ADMINISTRATIVE AMENDMENT

SITE DEVELOPMENT PLAN

ENGINEER'S SEAL	WEST BLUFF RETAIL CENTER	DRAWN BY BDG
	OVERALL SITE PLAN FOR SUBDIVISION	DATE 8-09-00
	TERRA WEST, LLC	EPC-SP.DWG
	8509 JEFFERSON NE ALBUQUERQUE, NEW MEXICO 87113 (505)858-3100	SHEET # 1
RONALD R. BOHANNON P.E. #7868		JOB # 980063

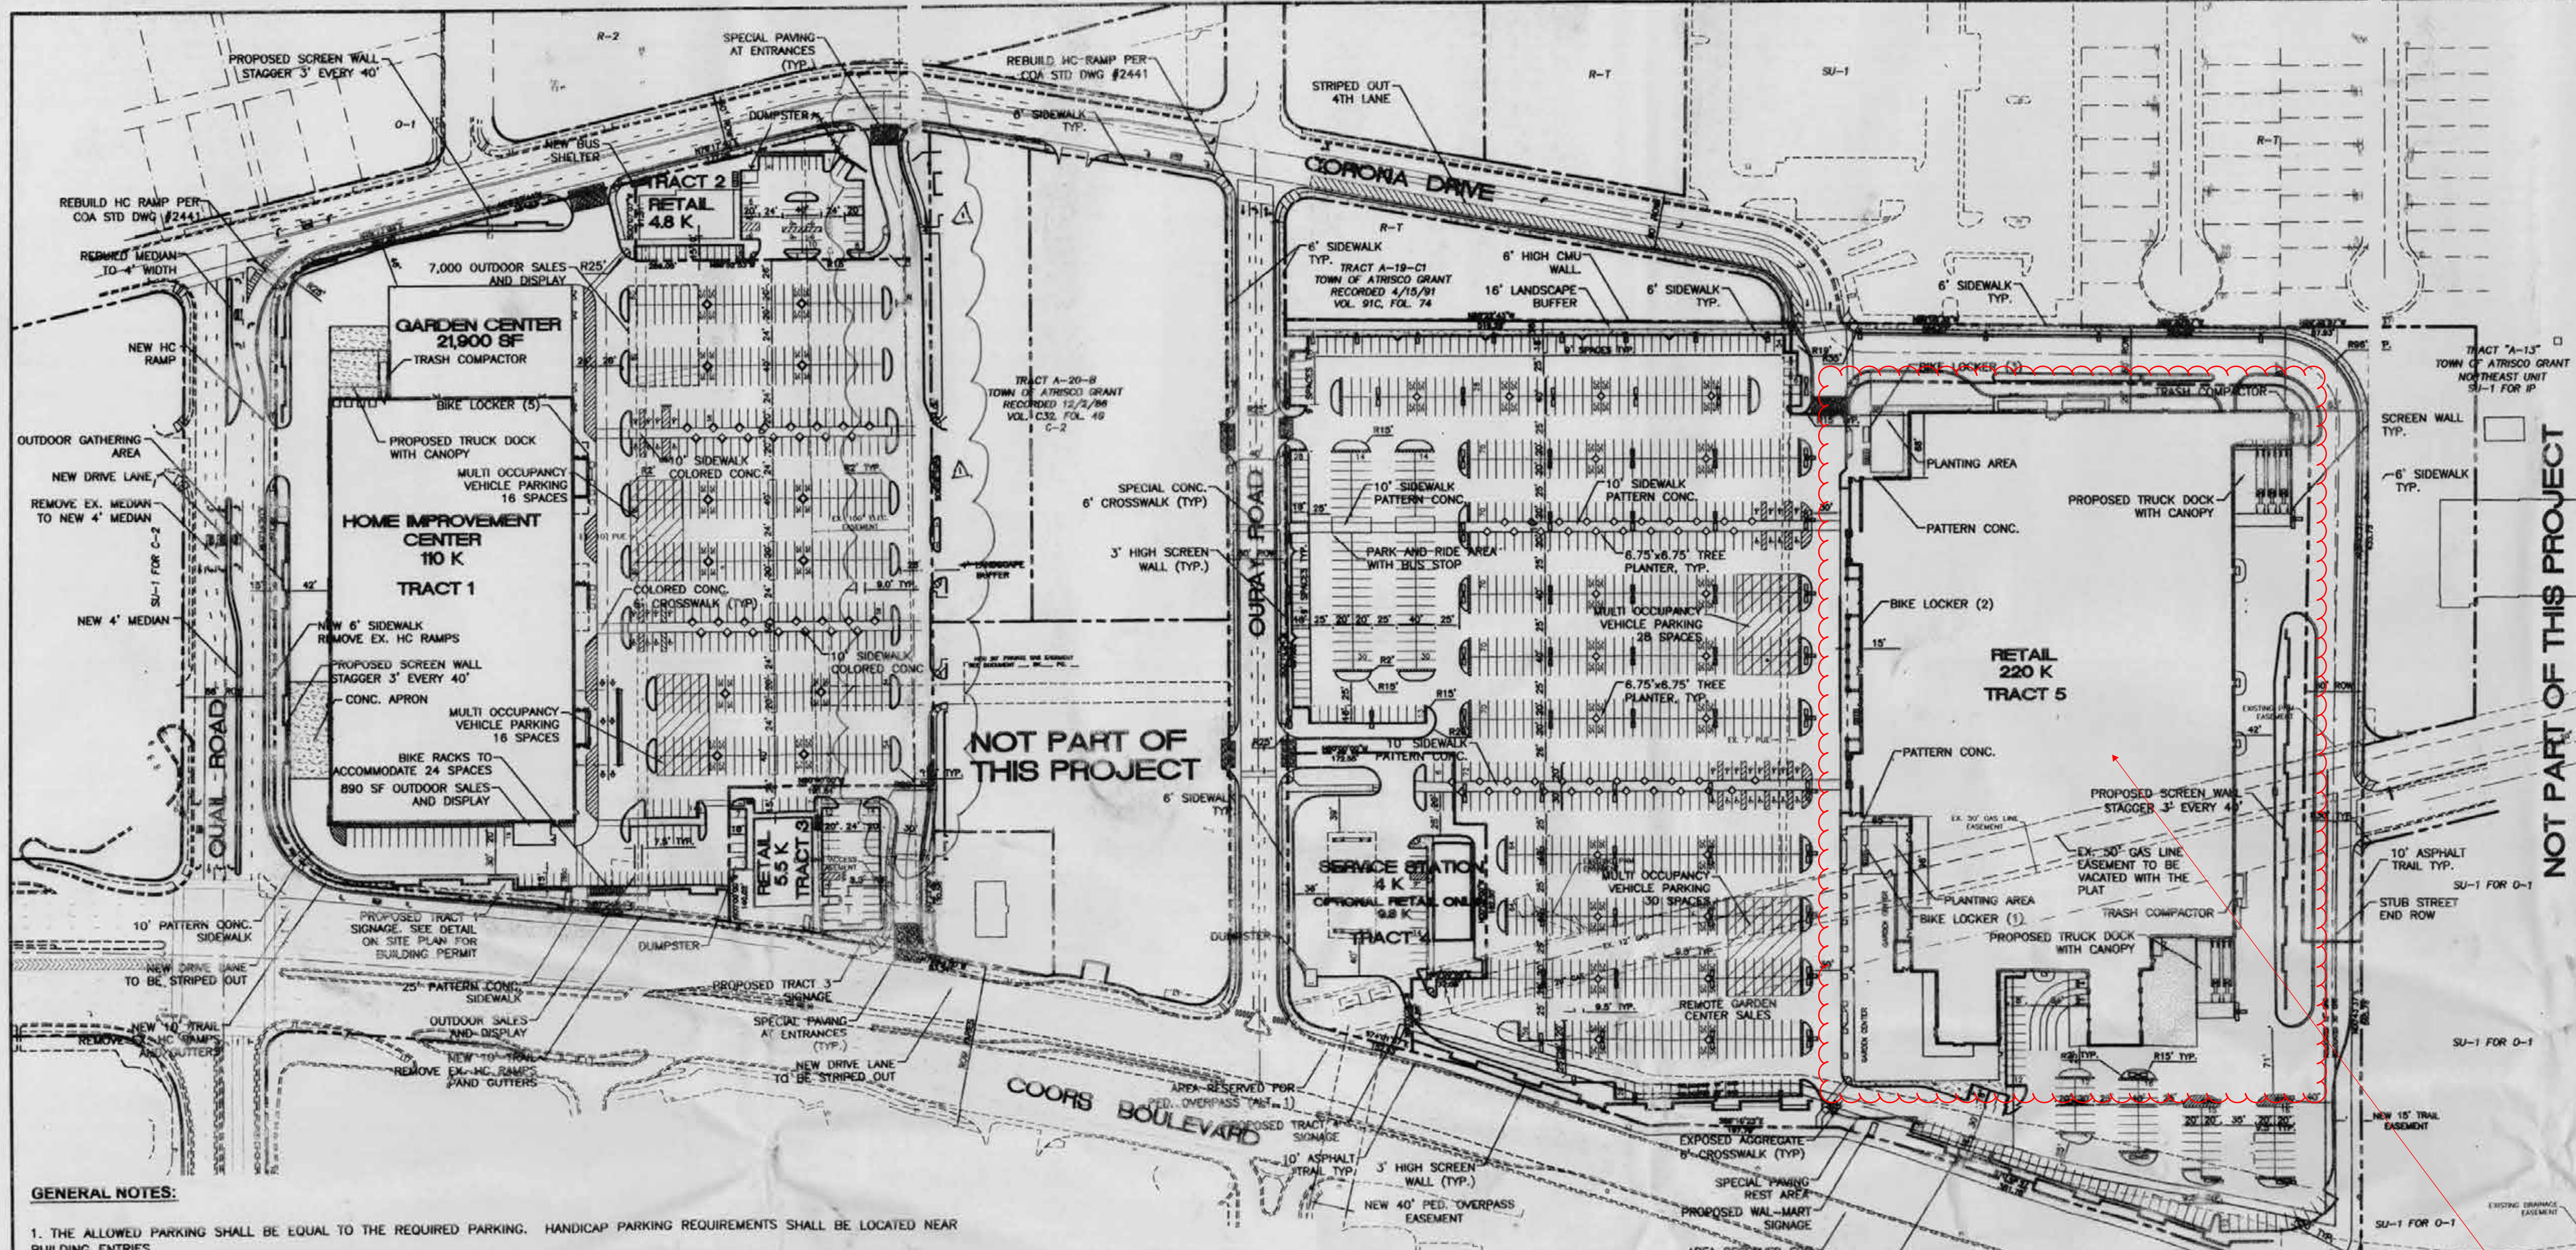
A Added Access to Southern Parcel
